Re: New Industrial Live/Work (**MLDFY2023-0002**)
Plan Review and City Engineer Comments

MLD Planning Office Report Corrections/Comments - 2

City Engineer Review Comments – 2 February 2024

No Park Units LLC
New Industrial Live/Work
5260 N. Sawyer/Alworth St., Garden City, ID
UTILITY PLAN

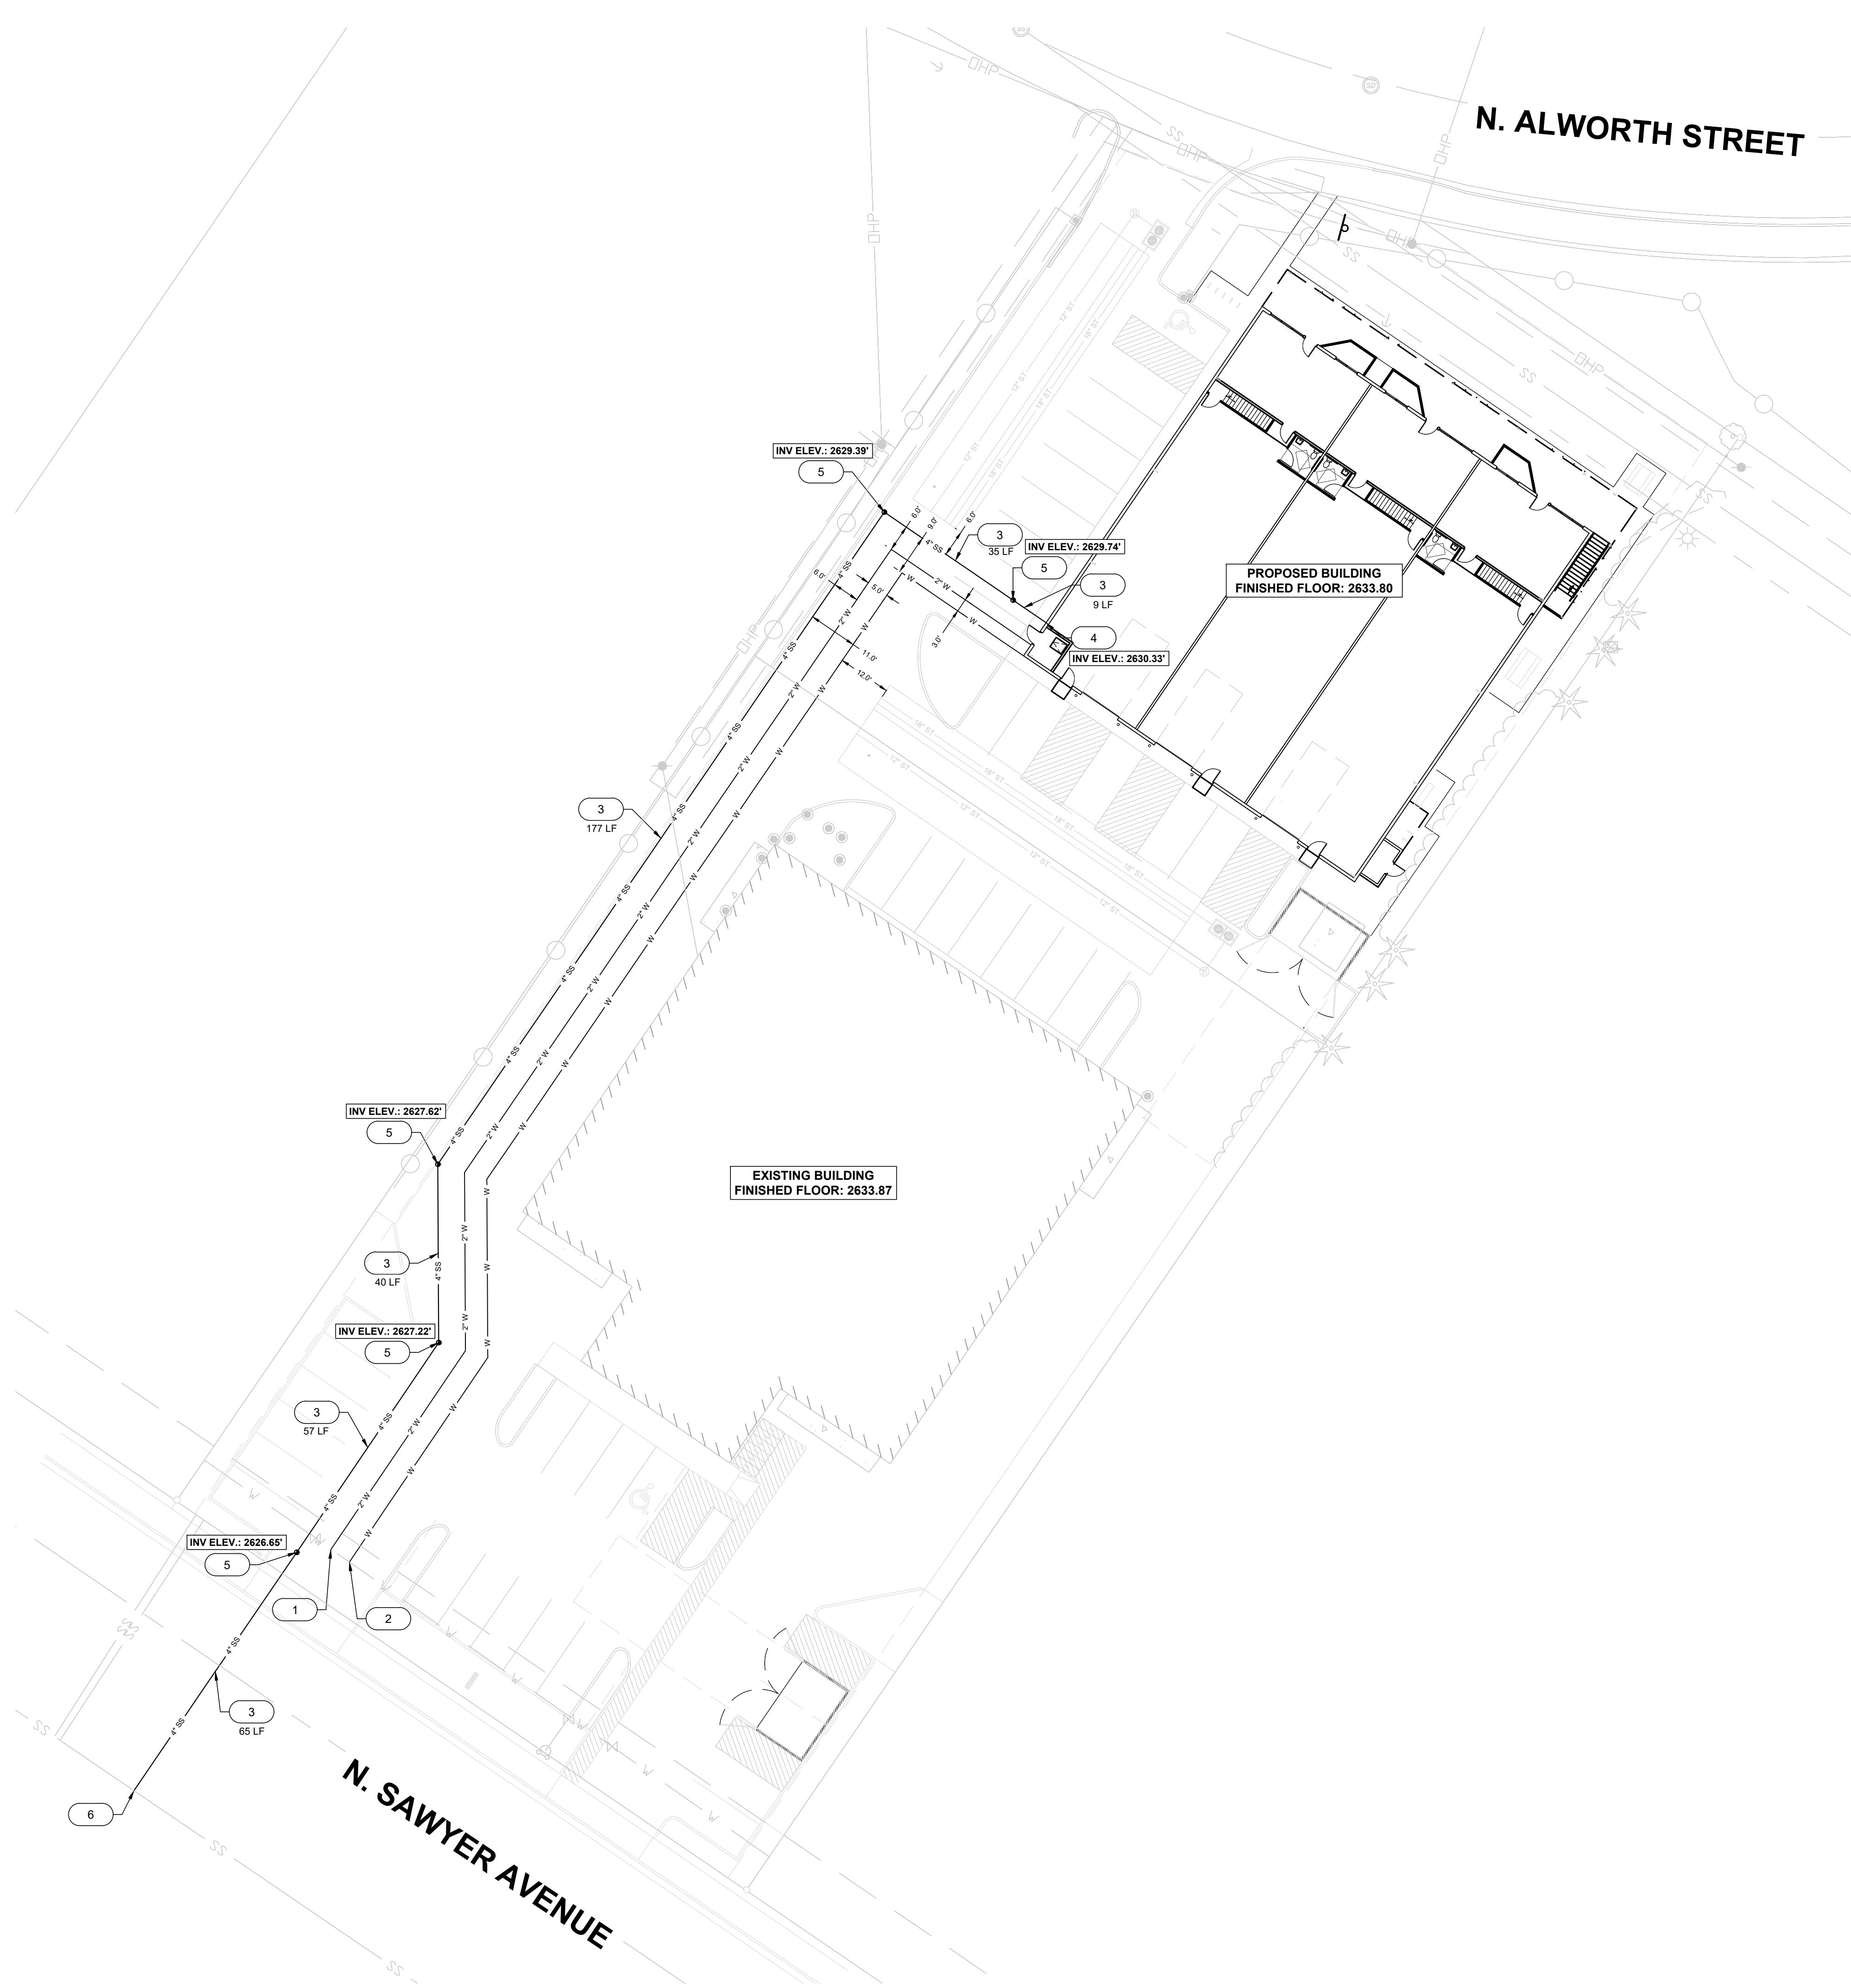
Item 8: *Garden City doubts that Boise City will allow the connection of the parcel adjoining Alworth to be connected to the Boise sanitary sewer line. Said line is an interceptor. Any direct connection would be a connection intrusion to the interceptor and would be unmonitored. Garden City would prefer/require to have all new connections to the Garden City collection system. This may require an upgrade to the existing sewer connection that runs across Sawyer. The sewer connection will need to be discussed with Garden City Public Works staff. As noted, we will not perform a full review of construction plans with a MLD application; however, we do have a comment on the proposed sewer connection. As the service line is almost 400 feet long, the fall needed is approximately 8 feet. Is adequate grade available? We do not see any elevations on sheet C4.0. Another project in the area had to install main lines to be sure marginal but adequate grade was available. We want to be sure what method of sewer service is necessary. The city would probably not be open to accepting a mainline for service to a single new building. A private pump system may be the best option if grade does not work. This does not notably impact the MLD review, but please be advised that appropriate corridors/easements to benefit Parcel B via the servient Parcel A must be created. Please advise.*

Response: We have confirmed invert elevation for the proposed sewer connection and reviewed the Idaho State Plumbing Code and ISPWC details. Please see revised Sheet C4.0 which indicates invert elevations for the cleanouts and the point of connection to the building; adhering to a minimum slope of 1.0% and ability to provide an acceptable depth of 3.5 feet below the finish floor (approximately 2630.3 feet).
